Addendum No. 1
Page 1 of 2

TO: Prospective Bidders
SUBJECT: Addendum No. 1
PROJECT NAME: Romeoville B Entrance Canopy
JJC PROJECT NO.: B20016

- iii. RELOCATED WEATHER BARRIER OVER PLYWOOD
 3. Drawing 16/A-101, titled, DETAIL - METAL PANELS AT BEAMS.
 - a. AT BOTTOM OF BEAMS - REVISED WEEPING SOLUTION:

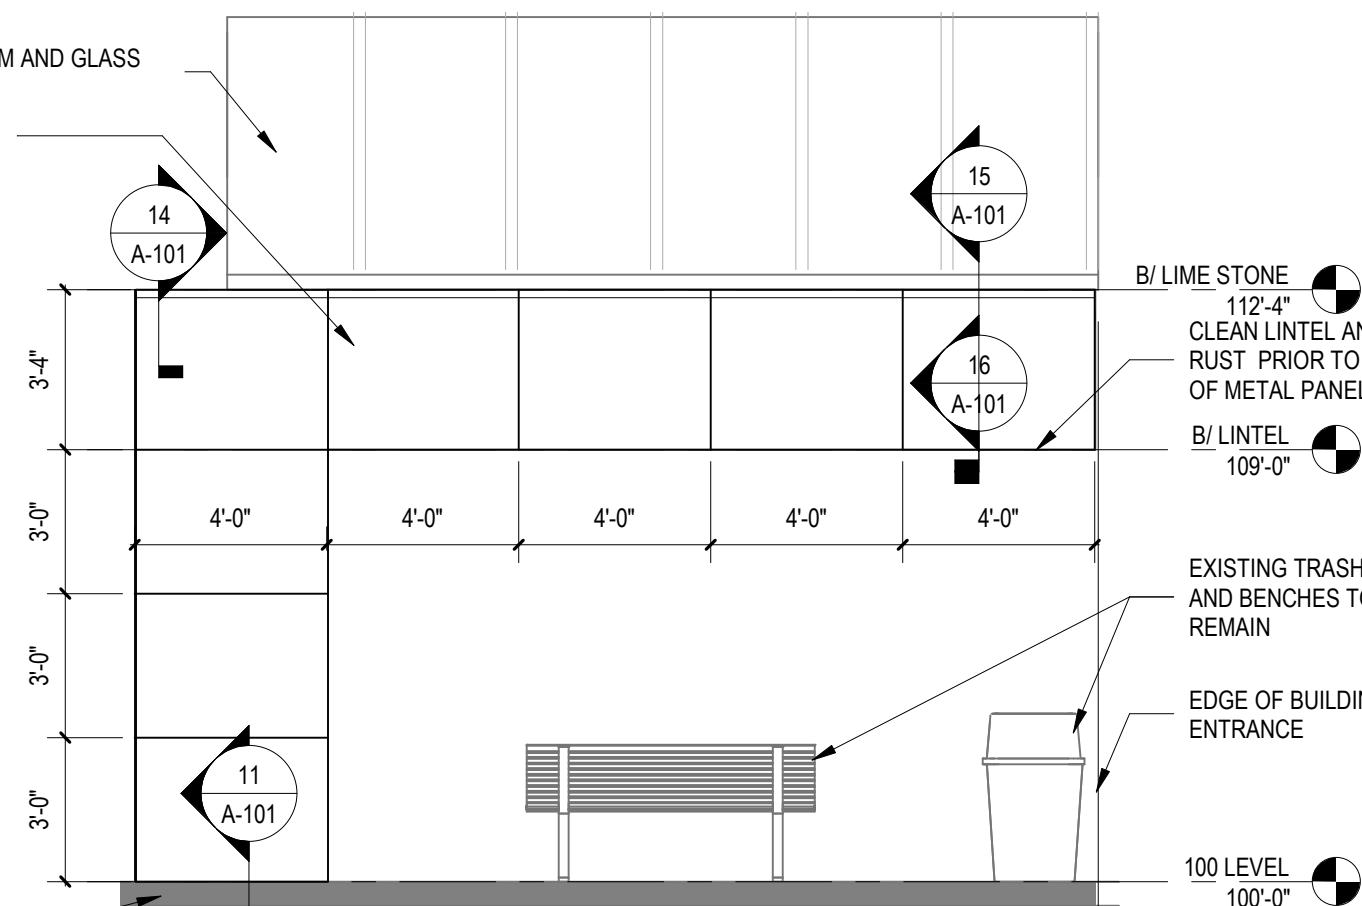
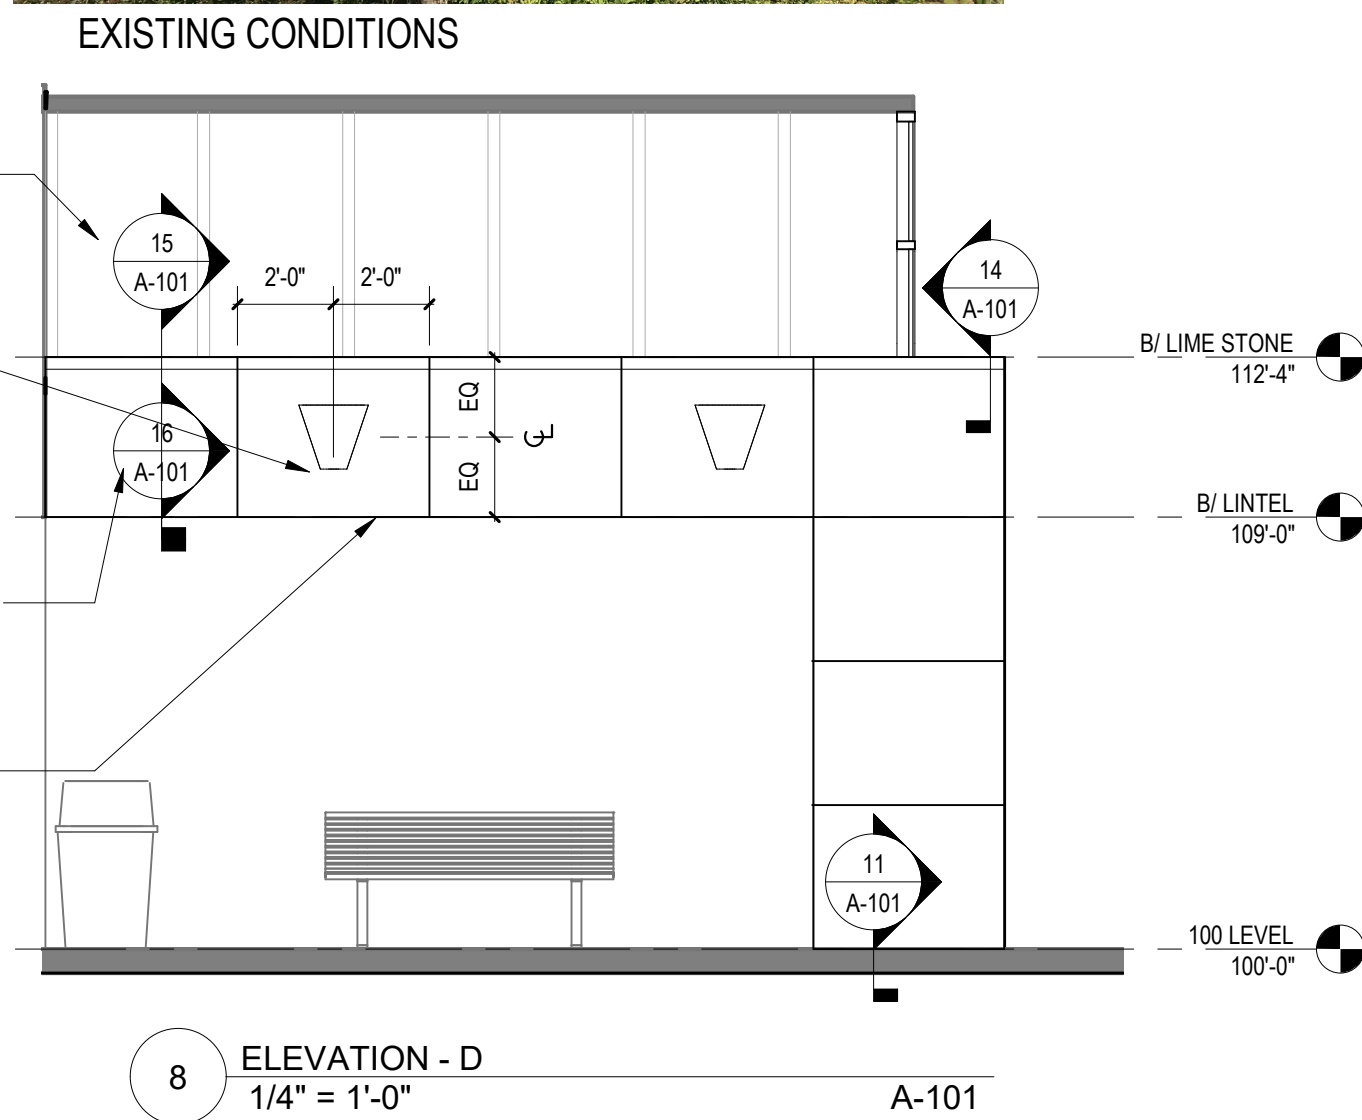
- i. REVISE METAL PANEL. IN LIEU OF AMC METAL PANEL PROVIDE BRAKE METAL TO MATCH AMC PANEL COLOR.
2. Specification section 02 41 00 2.02 A 1 of the project documents called "obtain the required permit." We were told during the pre-bid that only the Architect would inspect the work; no permits nor inspection will be required from the Romeoville village. Please confirm.
